State of Utah  
Department of Commerce  
Division of Public Utilities

**MEMORANDUM**

Subject: *In the Matter of the Acknowledgment of PacifiCorp's 2006 Integrated Resource Plan: Docket 07-2035-01 (Filed on May 30, 2007 as "2007 Integrated Resource Plan")*.

Date: August 31, 2007

**Figure 7.34 – Fleet Average Fossil Fuel Heat Rate Annual Trend by Generator Type**

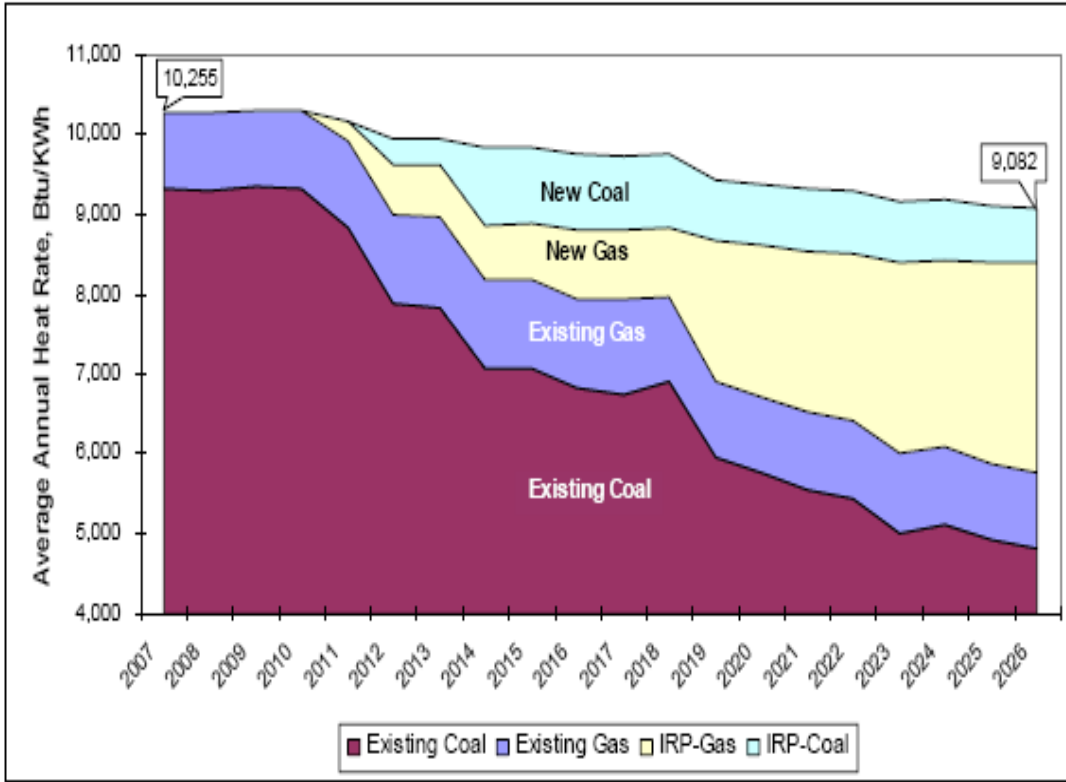
The report includes a graph that is reproduced below. Its title, "Fleet Average Fossil Fuel Head Rate Annual Trend by Generator Type" seems to indicate that it will give information as to how heat rate will improve within each category. However, that is clearly not what the graph illustrates. For example, existing coal will not improve to less than 5000 from over 9000 BTU/kWh over that time frame. Apparently what it does show is the contribution percentage of each fossil fuel type to the heat rate at a period of time.

The fossil fuel efficiency report in this IRP is not what the Division hoped the Company to provide since it only gives the Company’s goal without any analysis or background for how the Company intends to get to that goal. As stated in the Commission order: “Both the Division and the Committee concur any plan should be supported by a cost-benefit analysis and include environmental improvements and obligations that could affect efficiency.”
